May 4, 2023

From: Neil Whitehead, III Ph.D. and C. F. (Chuck) Newby for the *Conifer & South Evergreen Community Committee*.  
Re: Impacts of Groundwater Use, Wastewater Treatment, and Storm Drainage Management in Case No. 23-102980RZ Application for Special Use Permit for the Shadow Mountain Bike Park.

**Proposed Shadow Mountain Bike Park  
Impacts of Groundwater Use, Wastewater Treatment, and Storm  
Drainage Management on the Shadow Mountain Drive Community:  
Comments During the 1st Referral Process**

**Figure 1.** The Shadow Mountain Bike Park in Relation to the Turkey Creek Watershed.

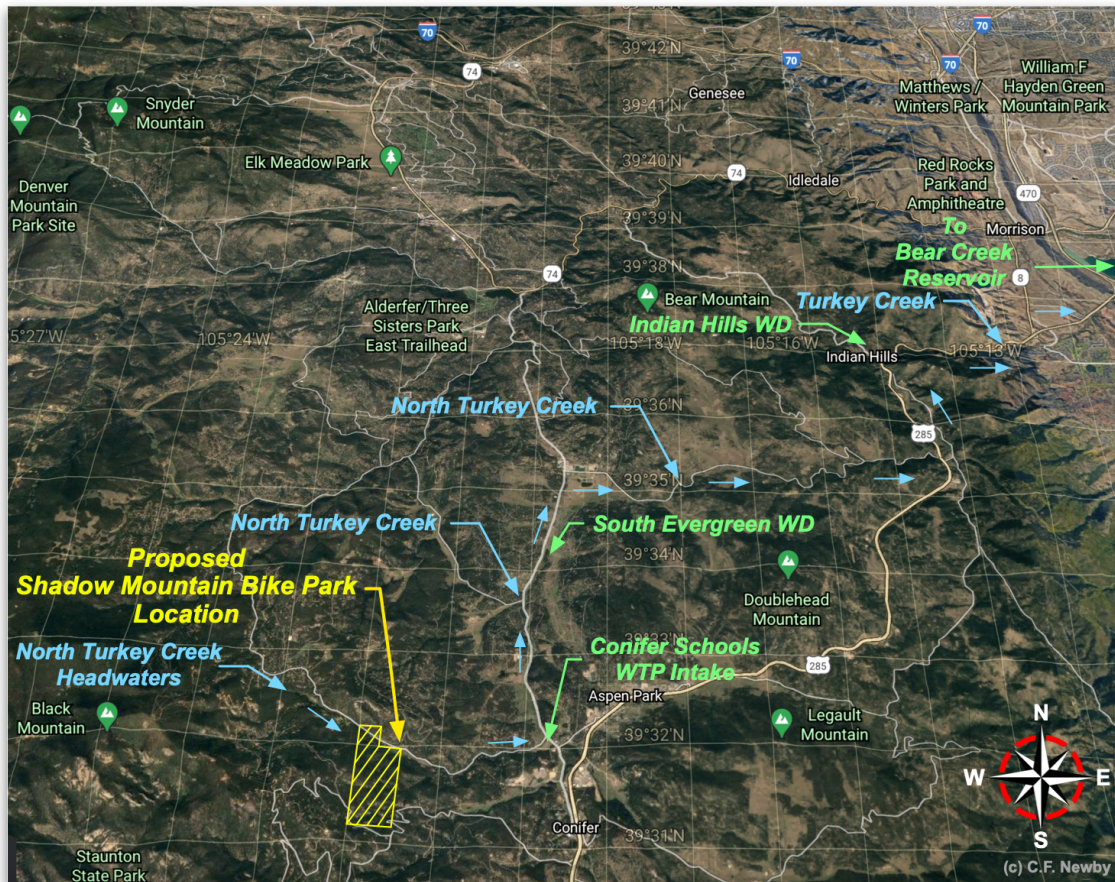
**Overview of Operations at SMBP:** The Figure 1 map illustrates that the location of proposed SMBP development within the sensitive Turkey Creek Watershed. The Applicant proposes to construct a chairlift-served, downhill mountain bike park facility that will include: a quad-chairlift apparatus extending ~2,000 ft that will transport riders from the base area to the top of Conifer Mountain, a two-story lodge building, maintenance buildings, a milling area, and a parking lot on a ~306 acre parcel managed by the Colorado State Land Board which will operate seasonally from March 1st to November 30th.

The chair-lift accessed mountain bike park is proposed on ~306 acres of State of Colorado land administered by the Colorado State Land Board. The map shown in Figure 1 places the Shadow Mountain Bike Park (SMBP, the Bike Park, or the Applicant) within the Turkey Creek Watershed at the headwaters of the North Turkey Creek. Additionally, drone video 15m:28s in length taken by *Conifer & South Evergreen Community Committee* (the Committee) shows the setting and superimposed design of the bike park here: [Save Our Mountain Meadow on Colorado State Land](#) The Jefferson County Planning & Zone Division (Planning & Zoning) case file webpages are here: [SMBP Case File Webpages](#)
